## HISTORIC AND DESIGN REVIEW COMMISSION

**HDRC CASE NO:** 2019-125  
**COMMON NAME:** ROW at 133 ROY SMITH  
**ZONING:** UZROW, RIO-2  
**CITY COUNCIL DIST.:** 1  
**APPLICANT:** Kevin Bowyer  
**OWNER:** City of San Antonio  
**TYPE OF WORK:** Installation of new network pole in right-of-way  
**APPLICATION RECEIVED:** February 26, 2019  
**60-DAY REVIEW:** April 26, 2019  
**CASE MANAGER:** Huy Pham

The applicant is requesting a Certificate of Appropriateness for approval to a new 33-foot wood pole to feature network node equipment at the right-of-way at 133 Roy Smith.

GC-3

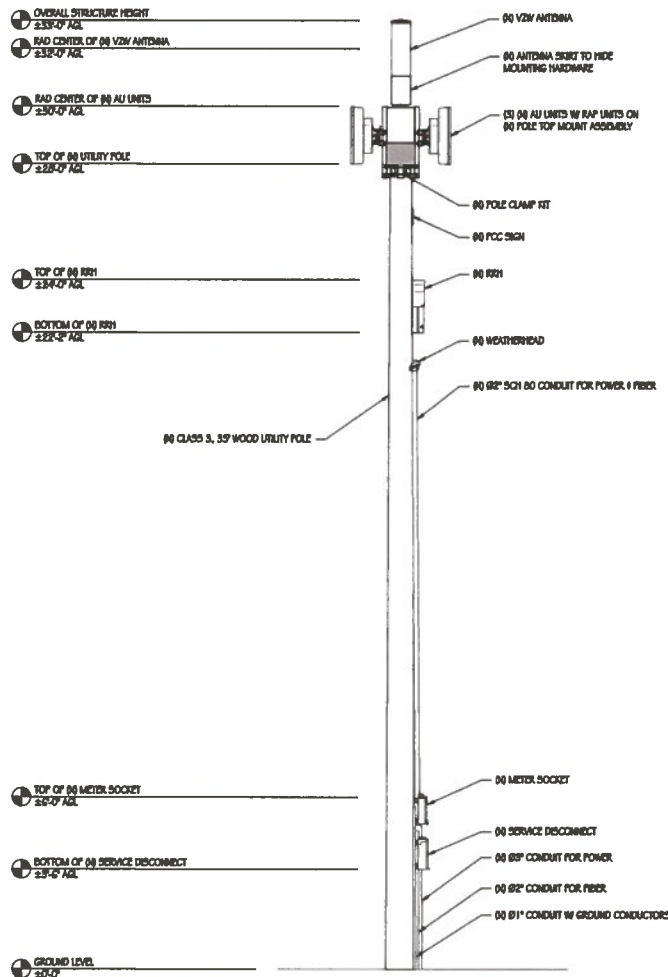
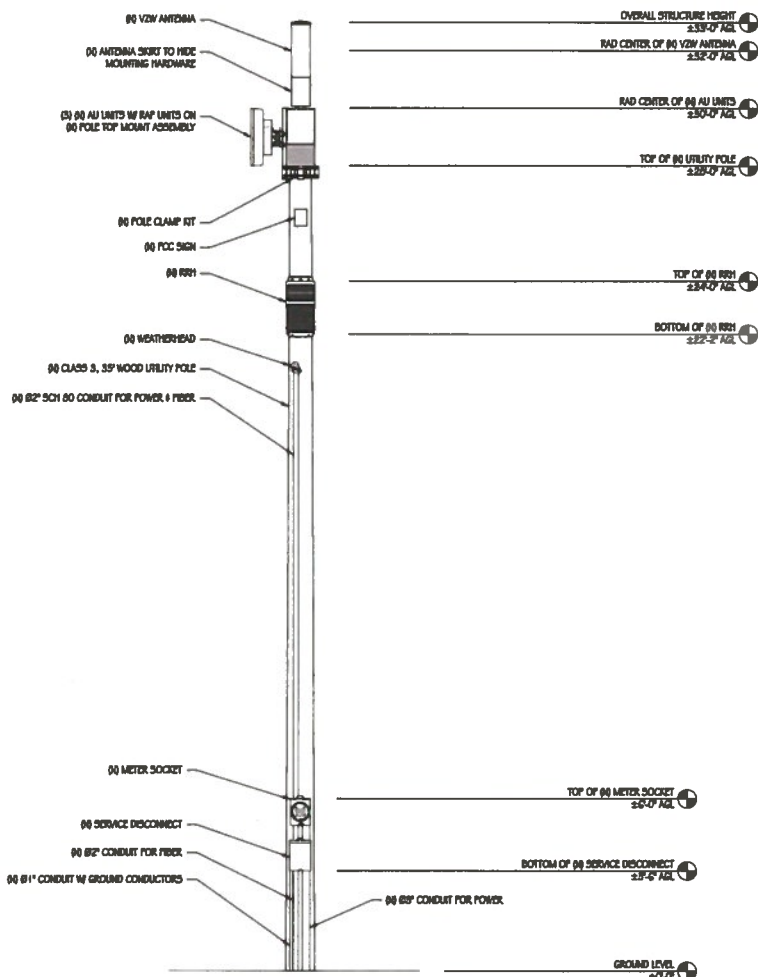
- e. HEIGHT – The applicant has proposed to install a wood pole with a height of 28 feet (28’) with equipment extending a total of 33 feet (33’) from grade. Per the Design Manual 3.B.iv., the height of new node support poles should not exceed the established predominant height of other poles and historic site elements located within 500 feet of the proposed installation. Staff finds that the proposed height is subordinate to existing poles within proximity.

- f. DIAMETER – The applicant has proposed to install a pole that is 32 inch (32”) in diameter excluding the meter boxes at the pedestrian level and the antenna cabinets at the top. Per the Design Manual 3.B.v., new poles should not exceed 8 inches (8”) in diameter at the widest portion of the pole. Staff finds that the proposed pole diameter is four times wider allowed by the design manual.

- g. DESIGN – The applicant has proposed to install a wood pole with a meter socket (box), service disconnect (box) and linear conduit up to six feet (6’), three (3) au/rap units (grey cabinets) that are 11.4 inch wide, 14.6 inch tall, and extend no more than one foot (1’) from the wood pole, a dual RRH unit (box), and an eight-inch wide (8”) cylindrical antenna at the top. The applicant referenced existing wood utility poles in selecting the pole type in this location. Per the Design Manual 3.B.: *The Historic Preservation Officer may require concealment of the support pole in the form of aesthetically appropriate street lamps, site elements, district signage, or other stealth methods. The color of any new support pole or concealment solution shall be determined by the Historic Preservation Officer based on site specific conditions.* Staff finds that no effort have been made to conceal or relate the proposed new pole to the existing context or site elements at N Mesquite – except the use of a wood pole. Staff that the applicant explore options to match the existing street lamp located at the southeast corner of the intersection at Roy Smith and Avenue A, if collocation is not feasible.

Staff does not recommend approval of the new network pole based on findings b through g. While approval may still be issued at the commission's discretion, the following requirements have not been met per the Right-of-way Network Node Design Manual:

- i. COLLOCATION - Documented efforts to explore a nearby collocation have not been submitted.
- ii. SEPARATION – The proposed pole is not separated from existing poles by more than 250 feet.
- iii. DIAMETER – The proposed pole is not less than 8 inches at its widest portion.
